Serial: RA-16-0002  
April 29, 2016

SHEARON HARRIS NUCLEAR POWER PLANT, UNIT 1  
DOCKET NO. 50-400 / RENEWED LICENSE NO. NPF-63

**SUBJECT: REQUEST FOR EMERGENCY OPERATIONS FACILITY (EOF)  
CONSOLIDATION**

**Evaluation of the Proposed Change**

Figure 2.4-1

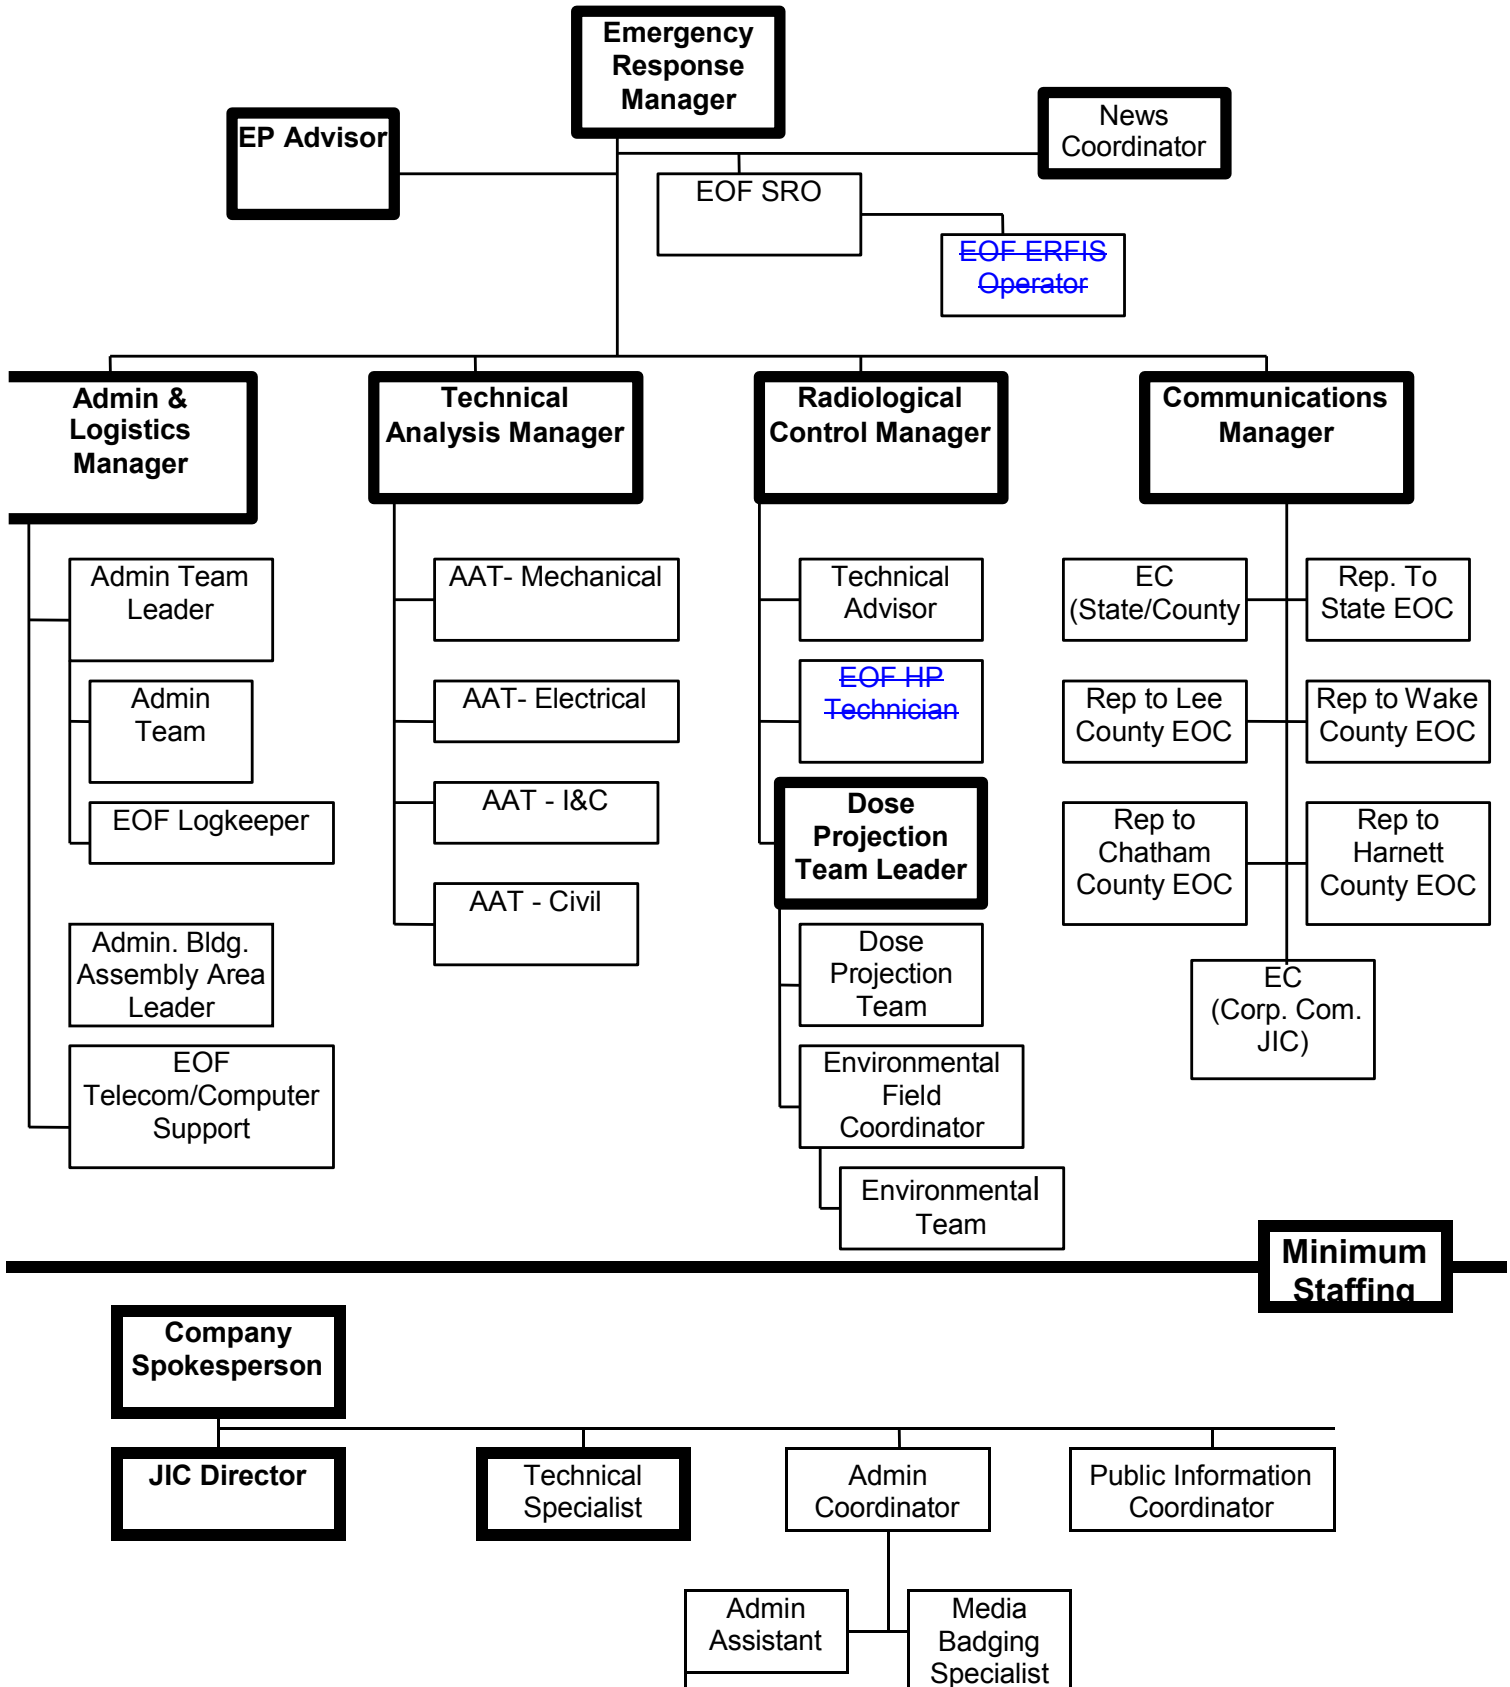
HNP Justification of Emergency Plan Changes		
Change Description	Requesting NRC Approval?	Justification
Figure 2.4-1, Page 37 Deleted the EOF ERFIS Operator and the EOF HP Technician	YES	<p>The Charlotte EOF will not have an ERFIS machine, eliminating the need for an ERFIS operator. As described in Section 3.7 of this amendment, a secure proxy server will allow the Charlotte EOF to access displays that are representative of the displays in the Control Room via the Duke Energy WAN and LAN.</p> <p>In addition the EOF HP Technician provides radiological support and monitoring within the EOF. Because the Charlotte EOF is located away from the site, it would be unaffected by radiological conditions, eliminating the need for this function.</p>
Section 3.3.2, Page 40, Item B Deleted "on ERFIS" from the plant status and parameters display function	NO	Change needed to appropriately reflect the new communication voice and data network. The basic function of receiving and displaying plant status and parameters data was not changed.

**FIGURE 5.1.1-3**  
**EMERGENCY RESPONSE FACILITY LOCATIONS**

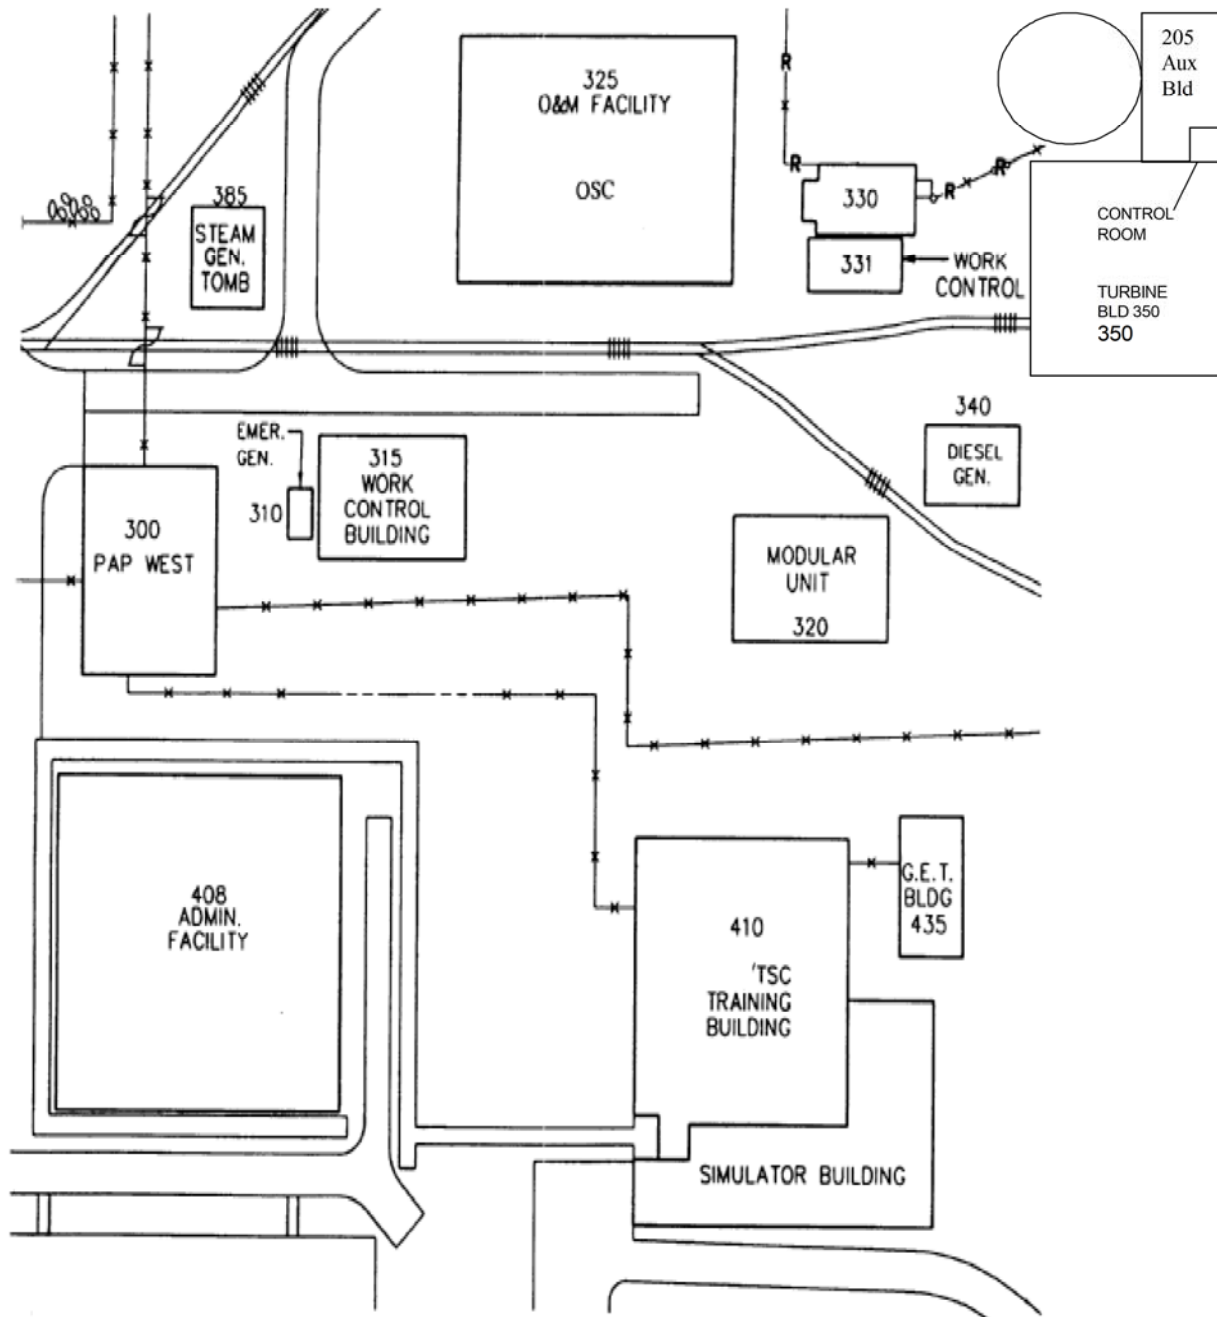
Figure 5.1.1-3, Page 23 Removed "EOF" from the name of building 410 "EOF/TSC Training Building"	YES	Changed name to reflect that the EOF will no longer be located in that building
Section 5.3, Page 35 Added "onsite" to the sentence describing additional assistance provided by personnel living in the site vicinity	YES	Since the Charlotte EOF will be offsite, this clarifies that the additional assistance from personnel in the site vicinity is applicable to onsite assistance.
Section 5.3.2, Page 38 Replaced "plant" with "ERO facilities" in the discussion of staff residence location	YES	This was made more generic to EOF facilities because the staff responding to the Charlotte EOF will not live in the plant vicinity.
Section 5.3.2, Page 38 Deleted "30-" (twice) and "60-" in the discussion of augmentation time and replaced "notification" with "declaration"	YES	NRC approval is requested to change the augmentation time of all 60-75 minute (from notification) responders to 75 minutes (from declaration). It is also requested to change the augmentation time of all 30-45 minute (from notification) responders to 45 minutes (from declaration). See Section 3.1.6 of Enclosure 1 of this amendment for further details.

FIGURE 5.3.2-1  
HBRSEP EMERGENCY RESPONSE ORGANIZATION

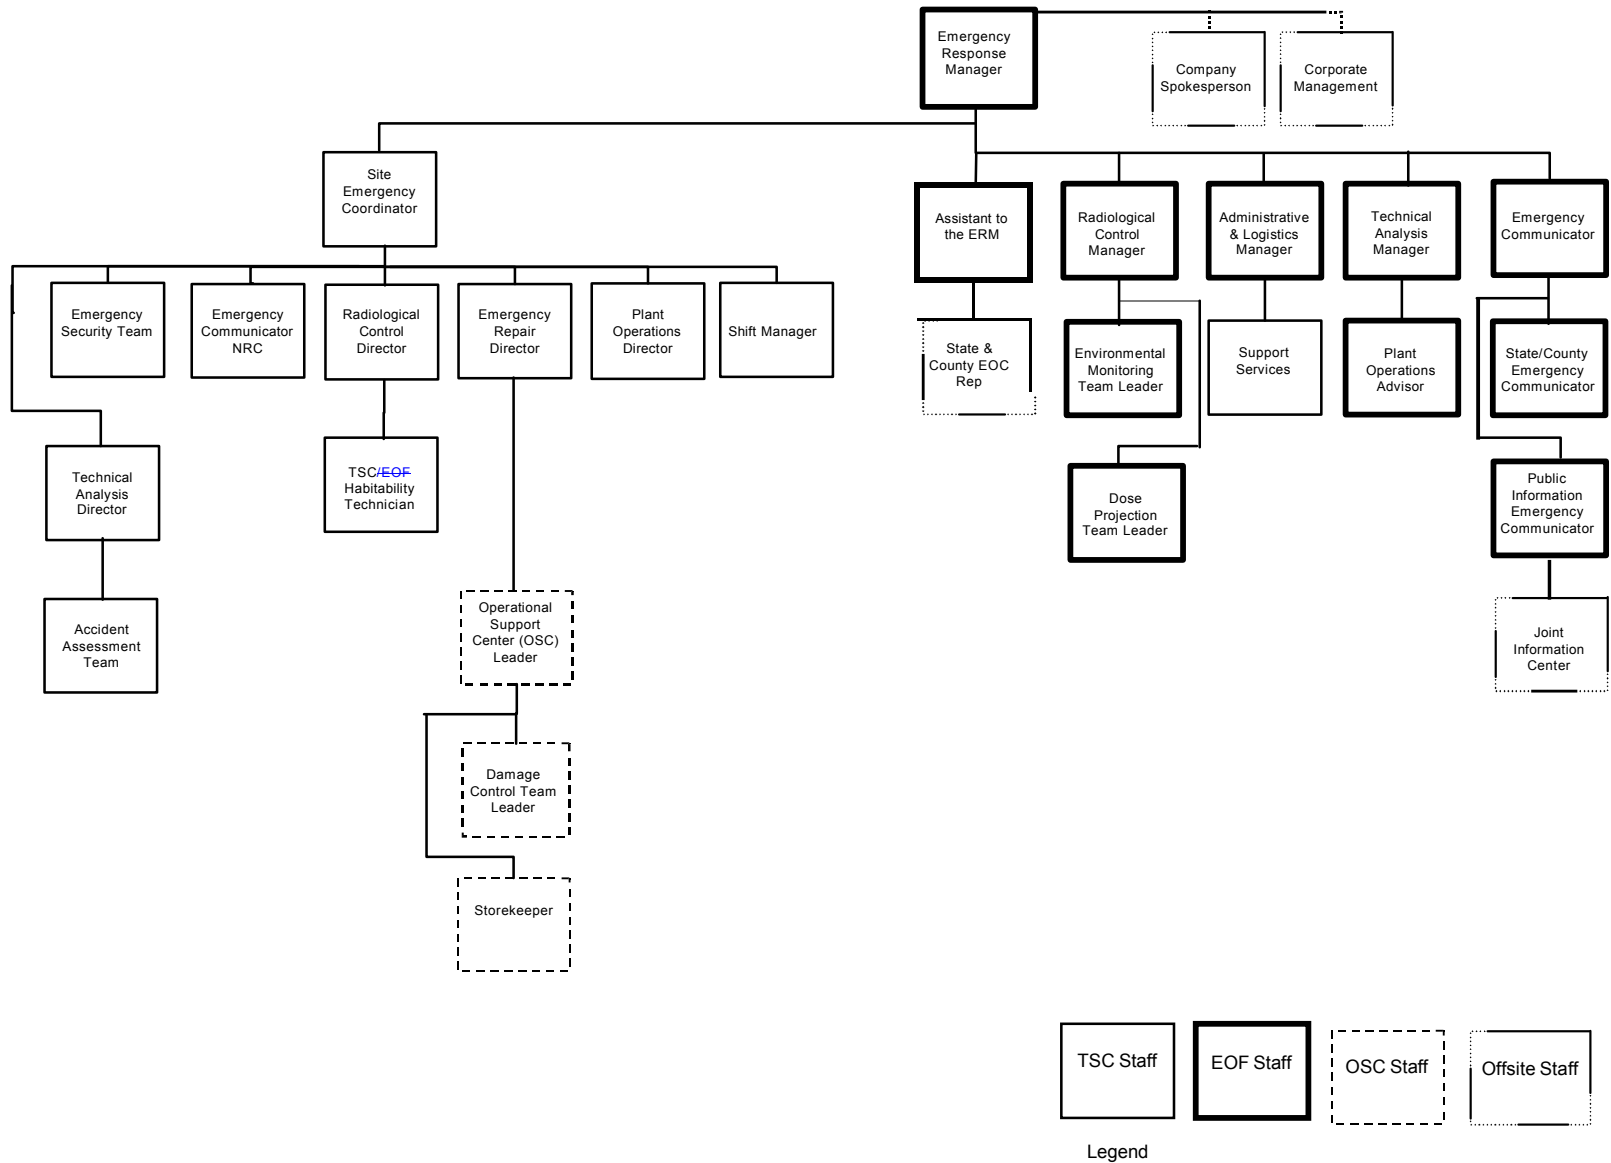
Figure 5.3.2-1, Page 69 Deleted "EOF" from "TSC/EOF Habitability Technician"	YES	The Charlotte EOF will not be located with the TSC, so this habitability technician will no longer support the EOF. Furthermore, the Charlotte EOF will not need this position. Due to distance from the TSC, there are no ventilation requirements (NUREG-0696) for the EOF and it would be unaffected by site radiological conditions.
Table 5.3.2-1, Pages 72, 74, and 75 Under the column "RNP ERO On-Call Position Title," replaced all instances of "30" with "45" and all instances of "60" with "75"	YES	NRC approval is requested to change the augmentation time of all 60-75 minute (from notification) responders to 75 minutes (from declaration). It is also requested to change the augmentation time of all 30-45 minute (from notification) responders to 45 minutes (from declaration). See Section 3.1.6 of Enclosure 1 of this amendment for further details.
